Letter for the record: AP 23-02- Appeal of Planning Manager decision on [WAP-23-01/WRG-23-01/FMA-23-01](#)

From: Appellants Karie Oakes and Teri Cummings

To: Mayor Rory Bialostosky, Council President Mary Baumgartner, City Councilors Leo Groner and Scott Erwin

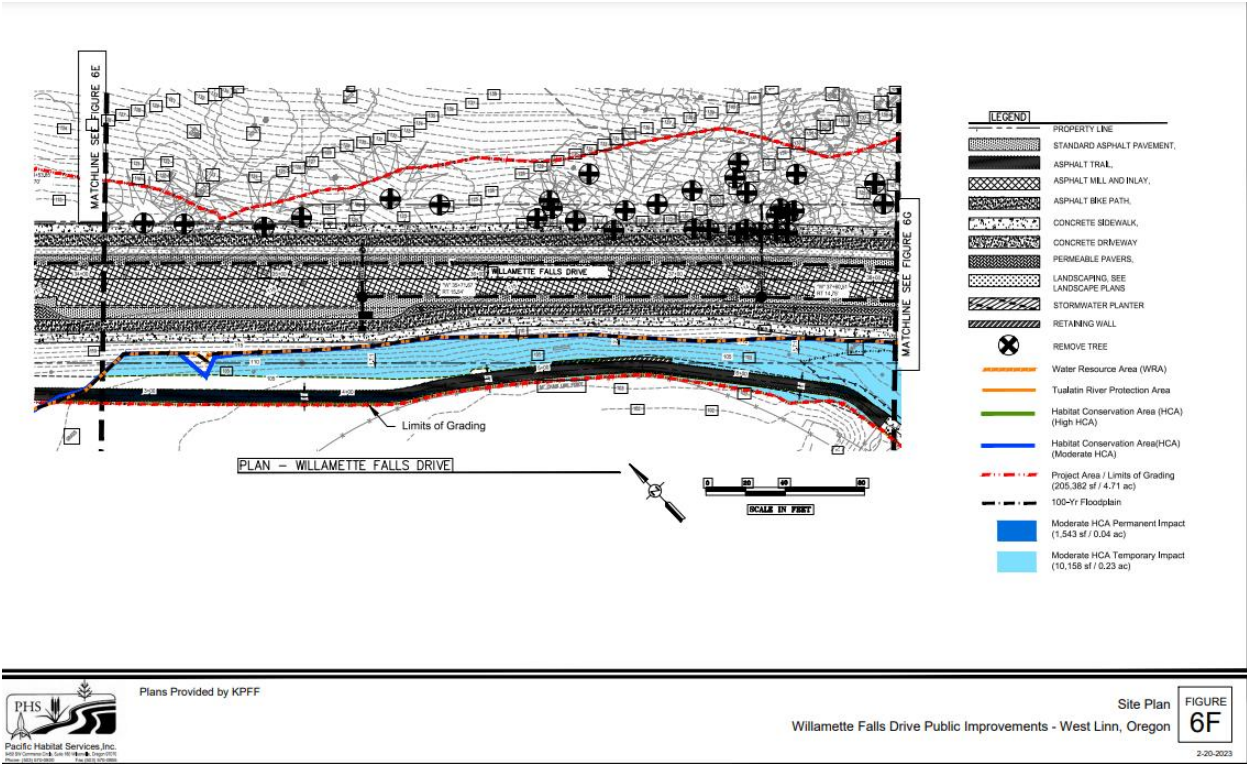
- c. The widened area pushes the adjacent pedestrian/bike pathway into moderate and high Habitat Conservation Areas (HCA) and pushes the existing park trail further into the flood plain area. A detailed environmental study for the proposed WFD improvements was not done when WFD Concept Plan was designed. However, PHS recent environmental report indicates where widened areas for optional parking spaces encroach into HCA areas and the flood plain. (See Figures 6F, 6H and 6I below)

Staff finding 33 does not mention the two significantly widened areas designed to accommodate proposed on-street parking encroach into medium and high HCAs and flood plain areas, nor does the finding state how many parking spaces are proposed, or for what purpose or CDC criteria.

On-street parking areas should be removed from the design to meet [CDC 28.110 A.2](#) criterion, below, which calls for a design that avoids and minimizes development activities in HCAs to the greatest extent possible.

FIGURE
6F

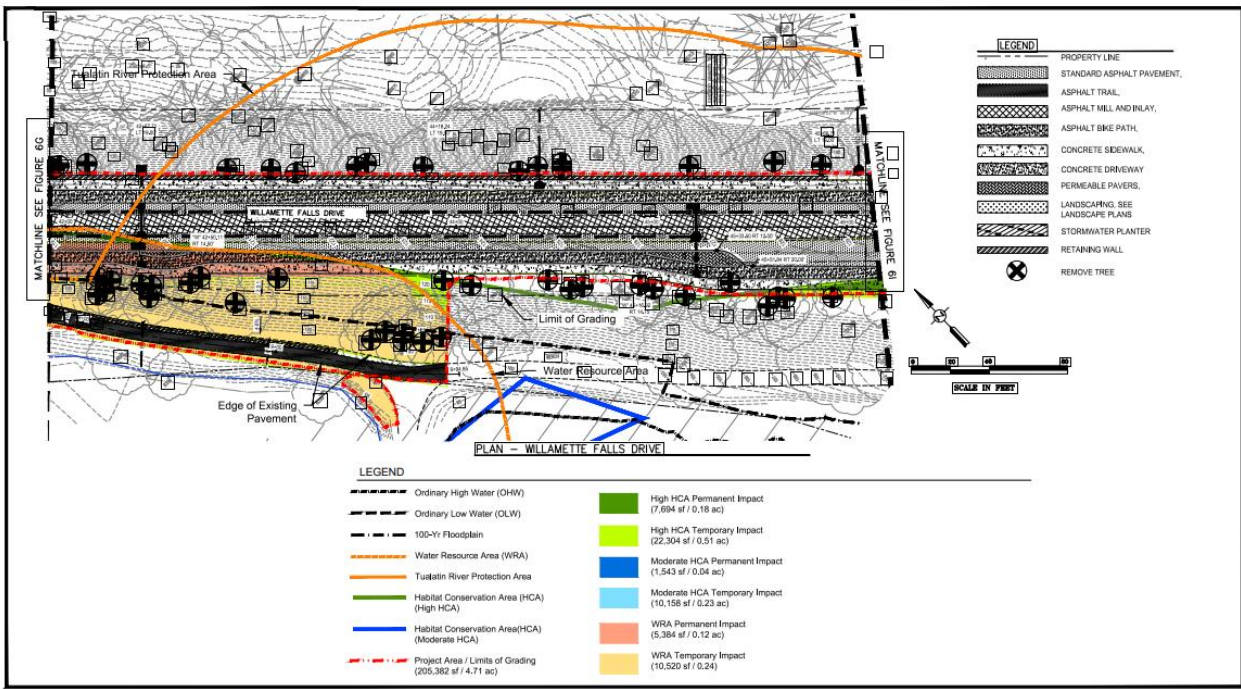
The widened area for proposed parking on the left side in drawing below pushes ped/bike path into blue HCA area.

Removing the parking areas would avoid encroachment into the HCA, the flood plain and trees to the greatest extent possible.

Site Plan
FIGURE 6H
 2-18-2023

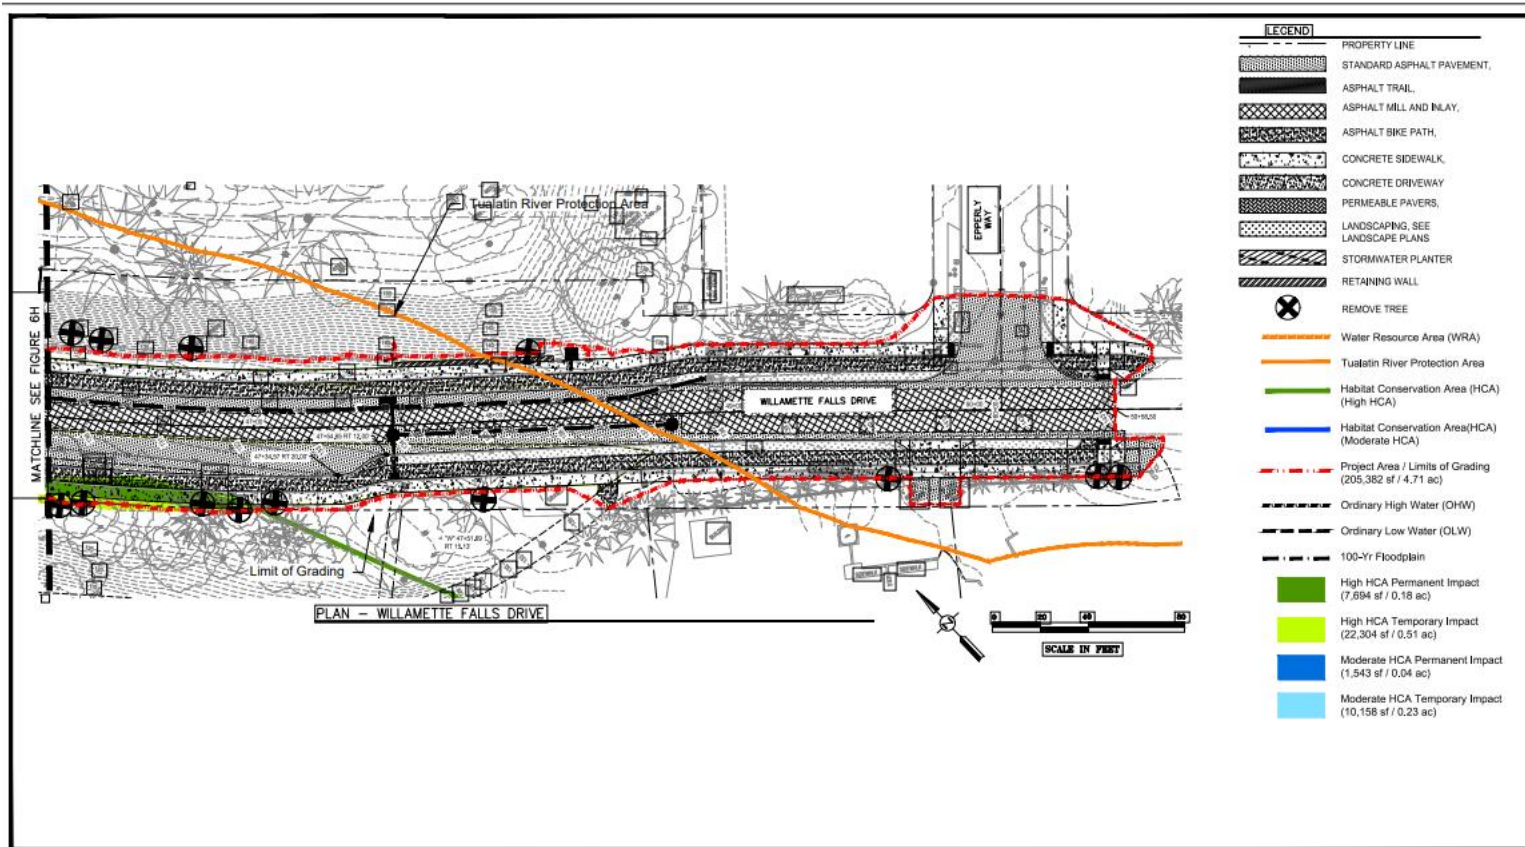
f. Figure 6 H below, shows on the right how the widened area for proposed parking near the proposed roundabout, pushes WFD improvements into the dark green High HCA area and four trees in the Tualatin River Protection Area marked with an **X** for removal.

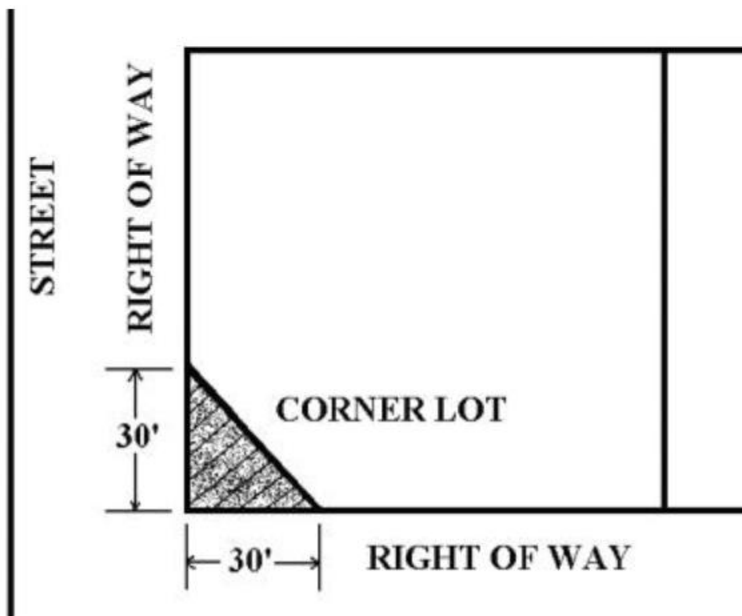
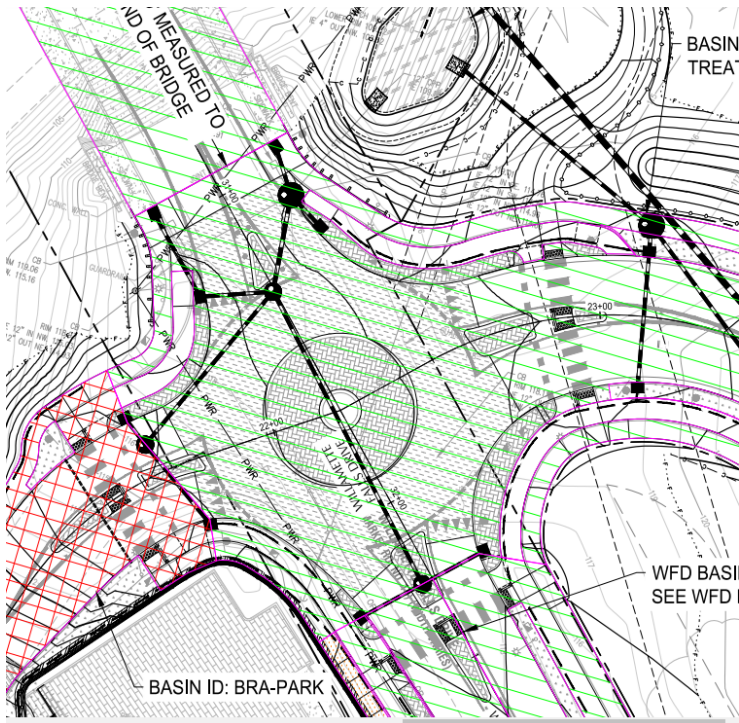
- The solid concrete and iron guardrails and on Fields Bridge are at least five feet tall. This exceeds [CDC 42.020](#) Clear Vision Area height limit of three feet tall, measured from the top of the curb.

- The distance from the southeastern guardrail to the corner of Fields Bridge Park driveway is approximately 27 feet. This falls short of the [CDC 42.020](#) Clear Vision Area criteria (see below) for at least 30 feet of clear vision area from the corner of an intersection to a fence, wall or structure that may obstruct visibility. The steep downward slope of the driveway could also impair line-of-sight approaching the intersection. The other side of

Fields Bridge appears to pose a similar situation except the Brandon Pl. driveway to the north might not be as steep as the southern driveway. See photos of measurements below.

Inadequate clear vision areas put school children, bicyclers and others at risk of not seeing or being seen by oncoming traffic while crossing the intersection. Safety measures must be explored.

1. Parking shall be removed and roadway realigned as far away as possible from the HCA and flood plain areas.
2. Adequate Clear Vision Area from bridge railings to the intersection shall be established per CDC Chapter 42.

Mitigation Plan **FIGURE 10**
Willamette Falls Drive Public Improvement - West Linn, Oregon
2-20-2023

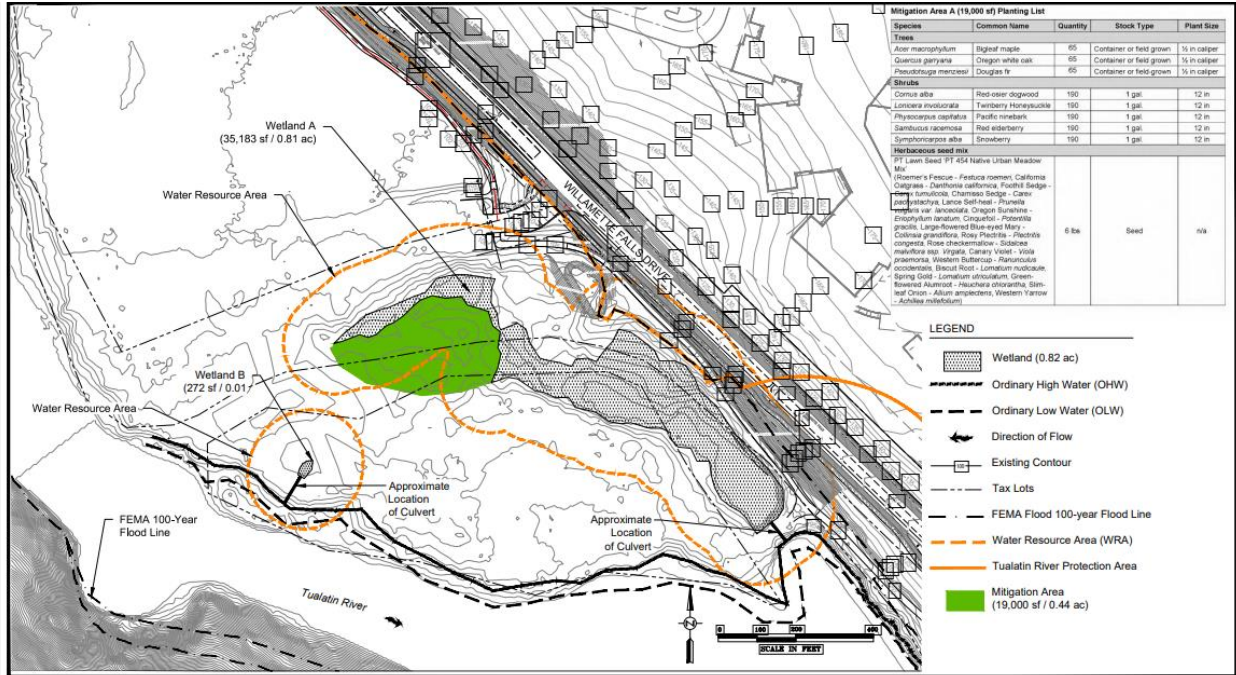
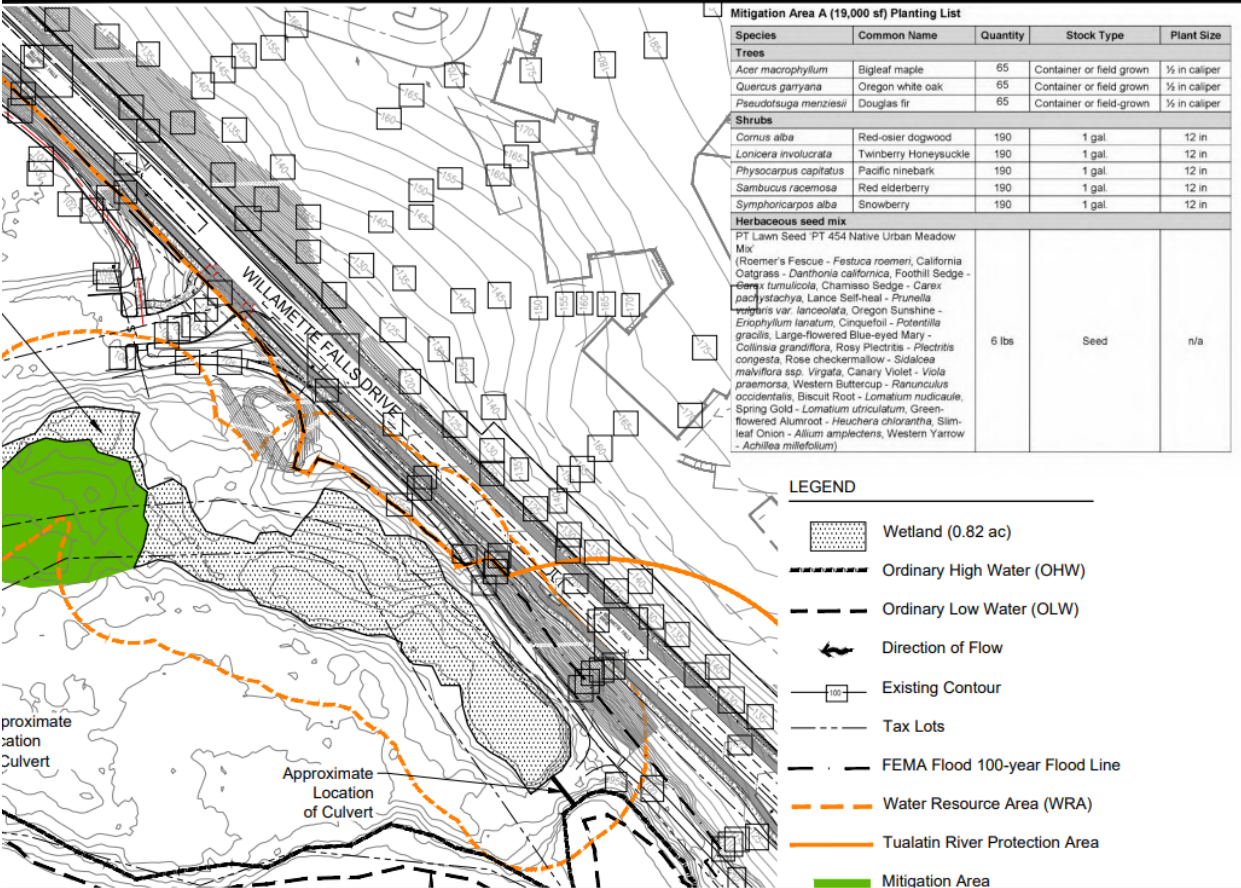
- a. The inconsistencies between the mitigation plan and planting plan make it too difficult to determine.
- b. The Mitigation Plan for Willamette Falls Drive Improvements, Figure 10, dated 2/20/2023 (pg. 121), indicates that 65 Maple trees, 65 White Oak trees, 65 Douglas Fir trees, 950 shrubs and 6# of seed will be planted on 19,000 sq. Ft (.44 acres) in "Wetland A" (shown in green) but does not indicate where these things will be planted or the name of the person who created it.

The planting list on Figure 10 above for Mitigation Area A (Pg. 121) does not appear to be a feasible plan for a .44-acre site, due to the potential mature size of the 195 trees plus 950 shrubs and 6# of seed scheduled to be planted.

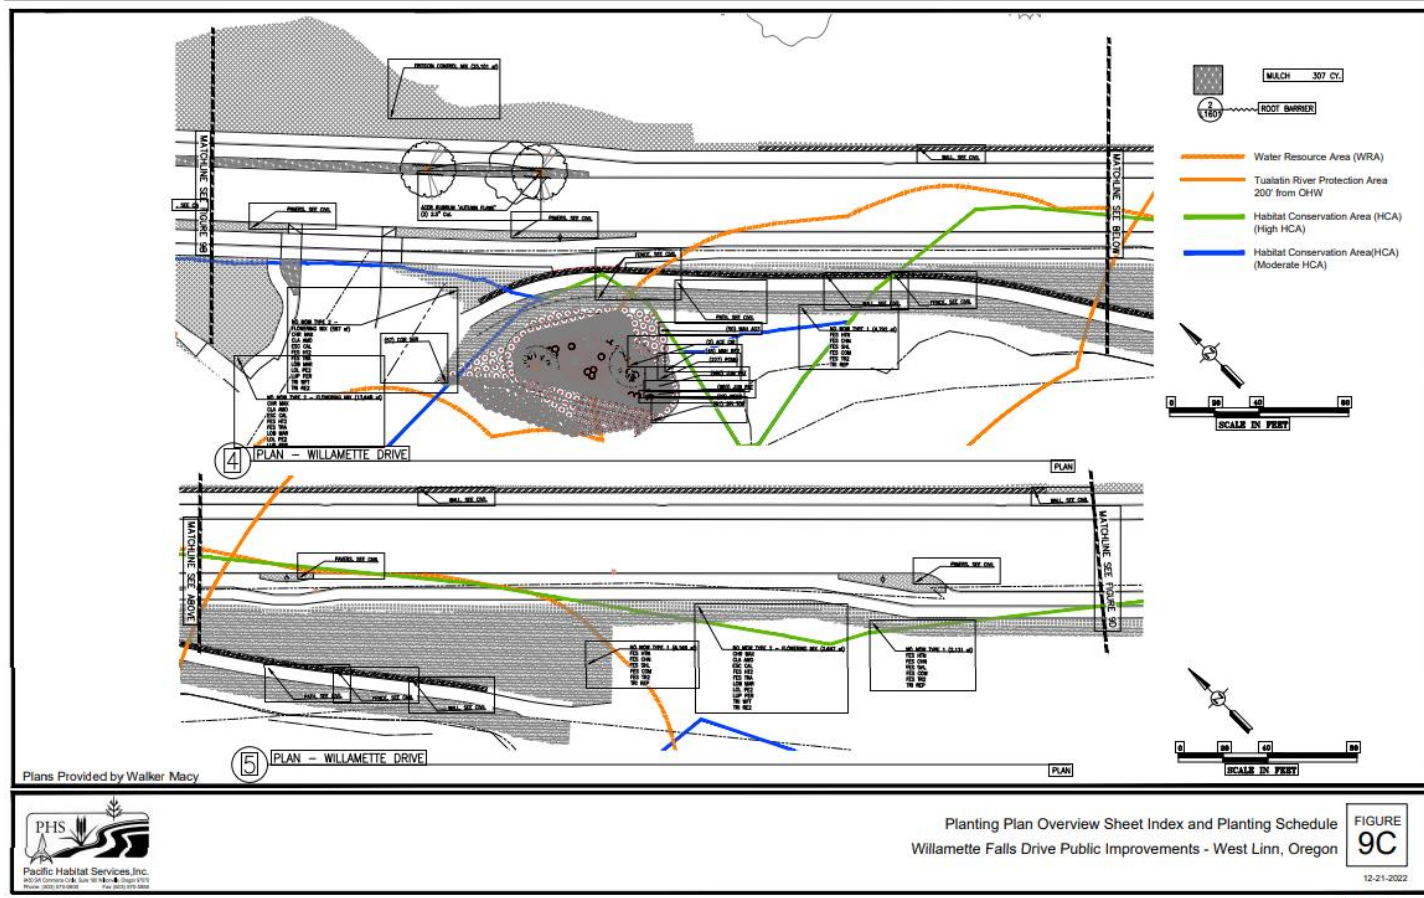
- c. Figure 9C, Planting Plan Overview sheet index, dated 12/21/22 (Page 119) below, clearly indicates where two maple trees and other vegetation will be planted but this is not located in the mitigation area shown in Figure 10 above.

There is a huge difference between the details in these two plans. We would like an explanation as to why they do not seem to coincide.
